E3-02372A-91

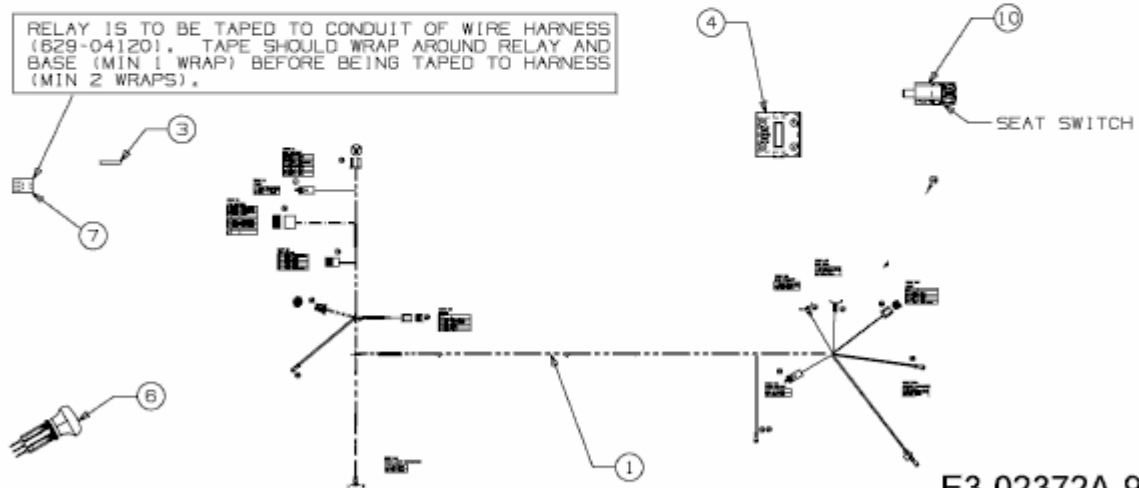
RELAY IS TO BE TAPED TO CONDUIT OF WIRE HARNESS (629-04120). TAPE SHOULD WRAP AROUND RELAY AND BASE (MIN 1 WRAP) BEFORE BEING TAPED TO HARNESS (MIN 2 WRAPS).
